Palisades Nuclear Power Plant
Docket 50-255
License No. DPR-20

Request for Additional Information on License Amendment Request: Palisades' Spent Fuel Pool Crane Upgrade

ENCLOSURE 1
REQUEST FOR ADDITIONAL INFORMATION ON SPENT FUEL POOL CRANE
LICENSE AMENDMENT REQUEST FOR PALISADES NUCLEAR PLANT

**EA-FC-976-01, CHARTS, "WIDENED RESPONSE SPECTRA
FROM FARSI ANALYSIS"**

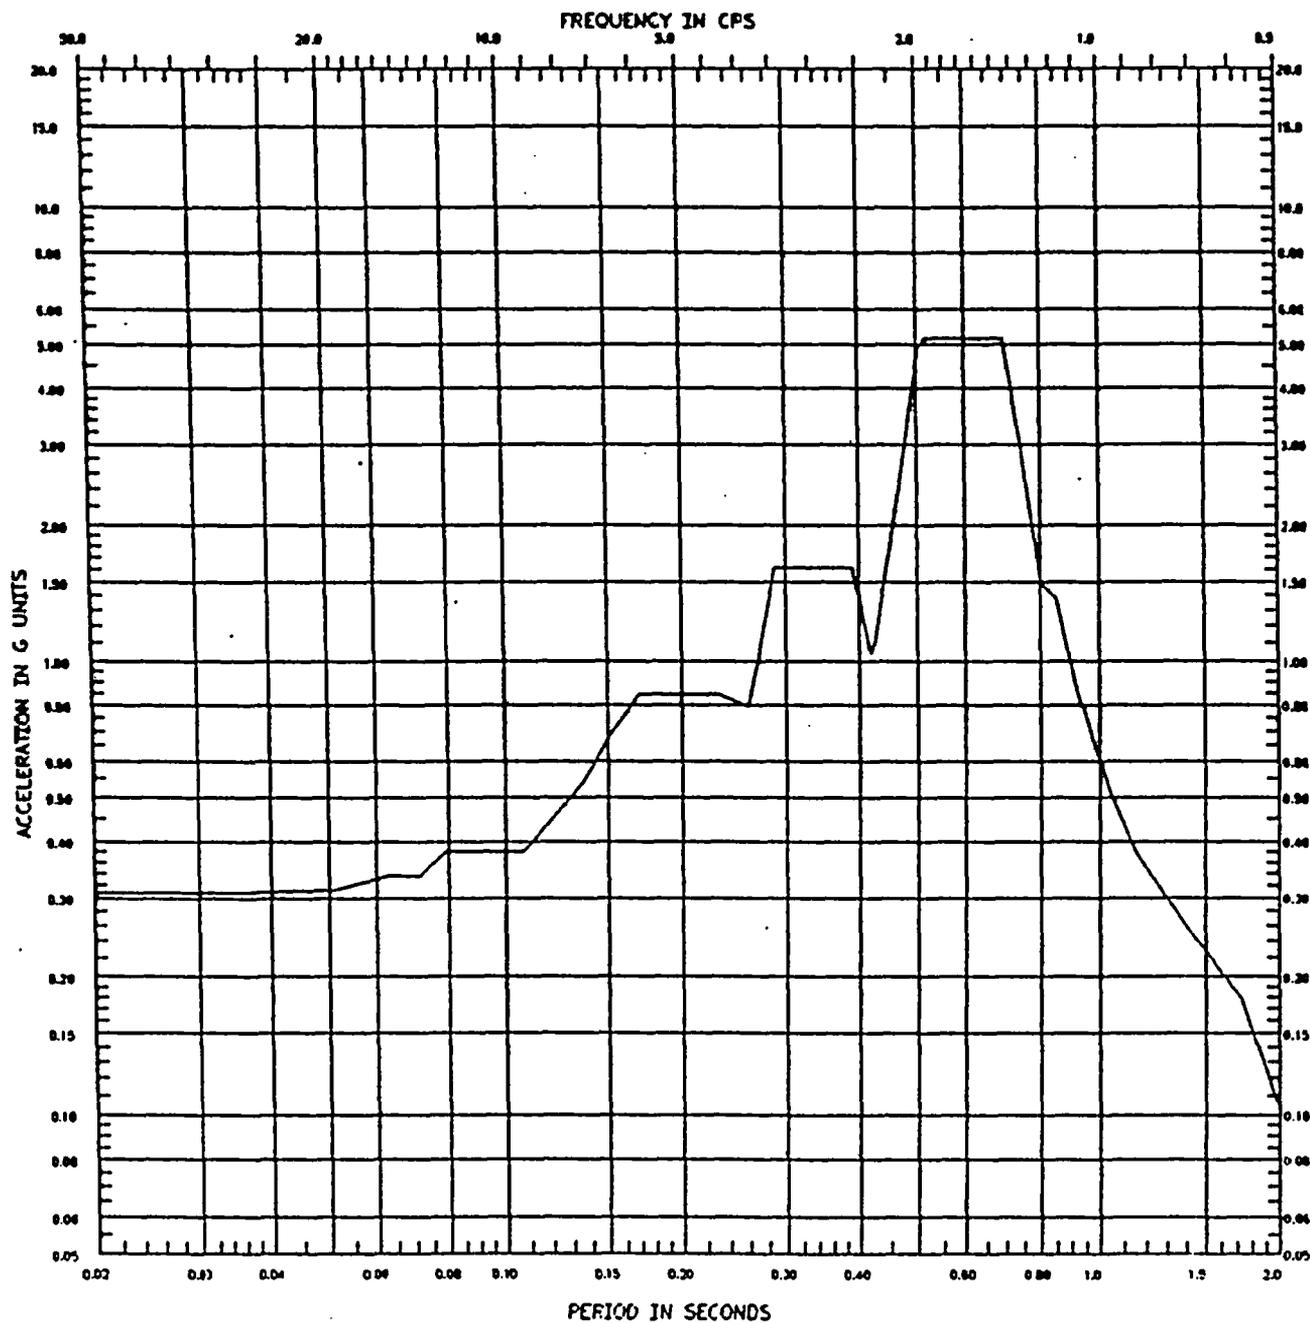
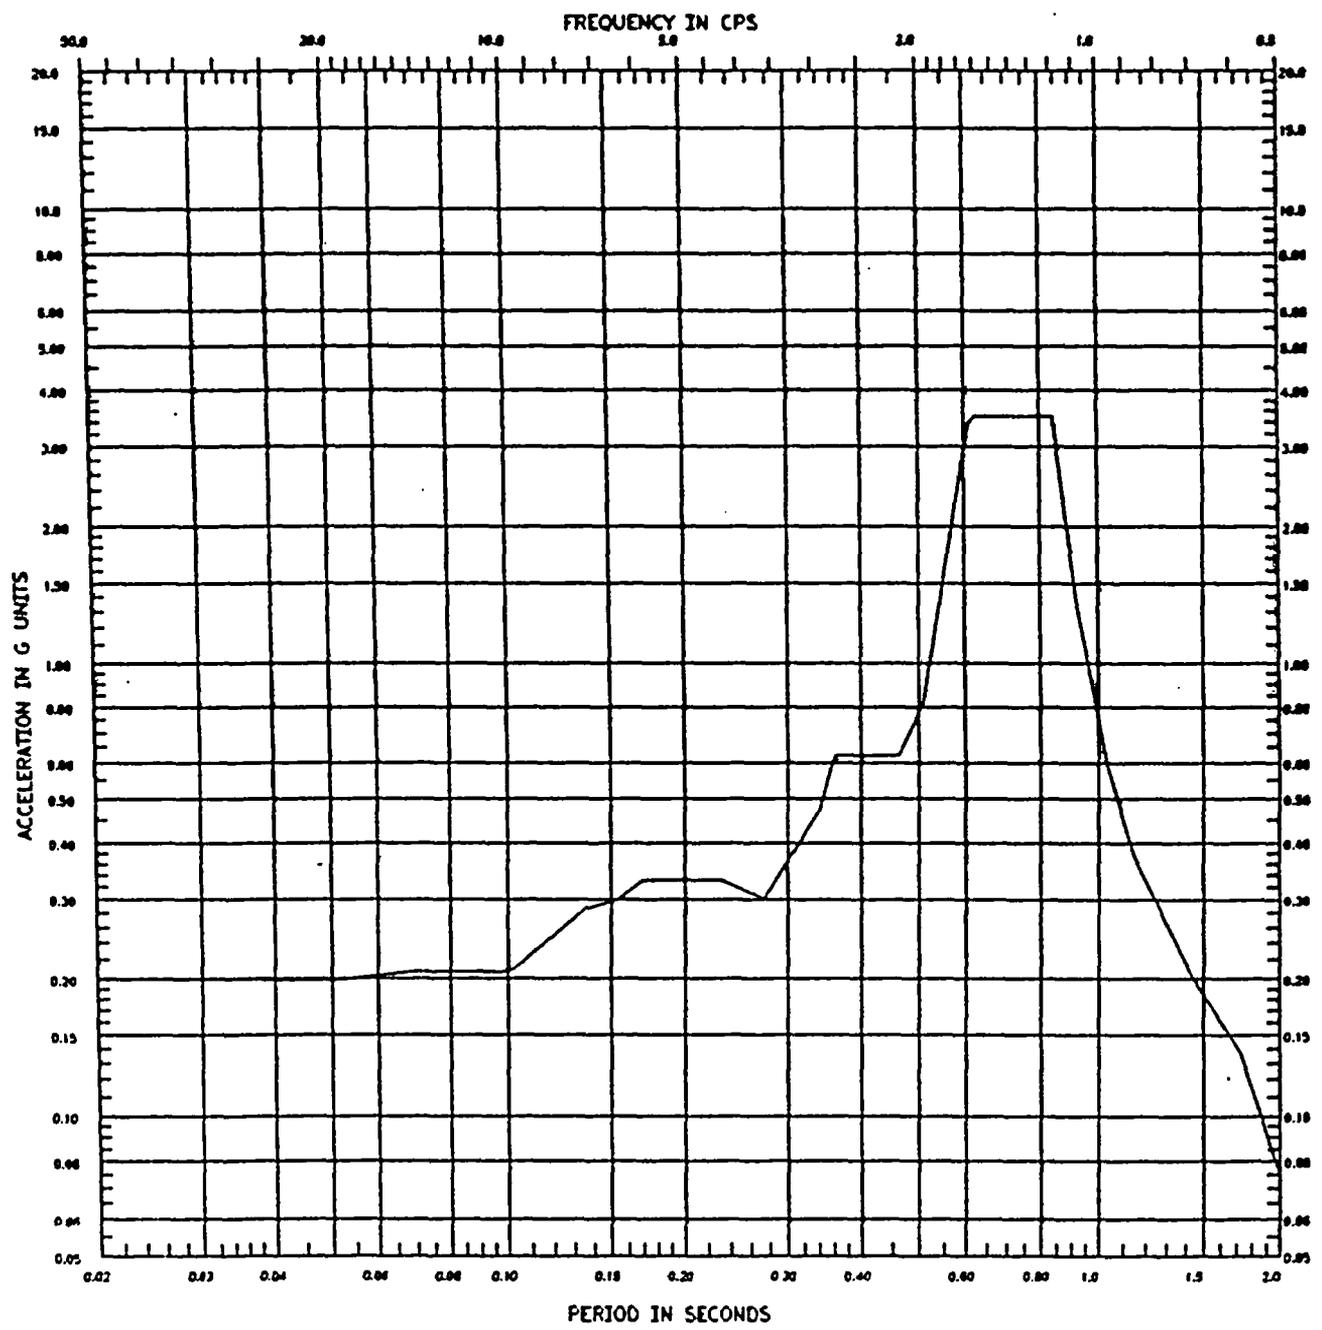
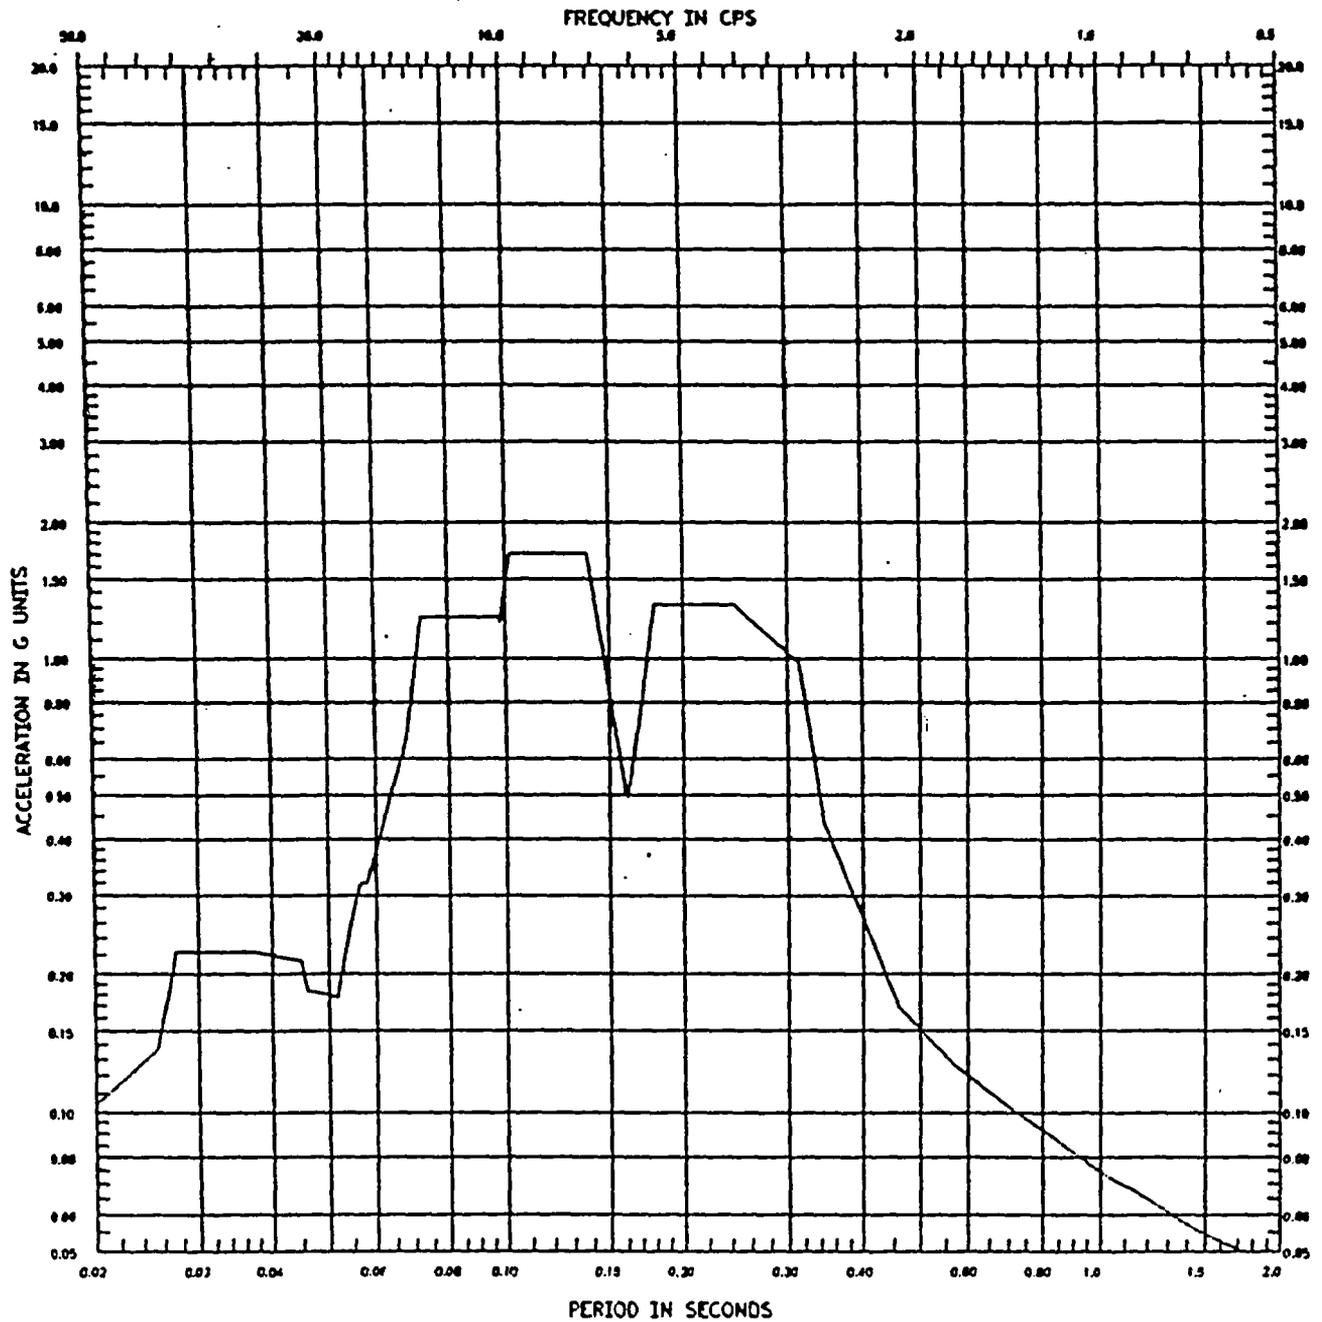
1. *Provide a more detailed summary of the structural analysis for the upgrade of the spent fuel pool crane.*

The spectrums, in the three directions from the three hoist conditions, were enveloped and 15% widened. These spectrum are for North-South direction, East-West direction and Vertical Direction. The plots of the widened response spectra for the three directions are shown in Attachment 1. These response spectra are used as inputs to other analyses, as described below.
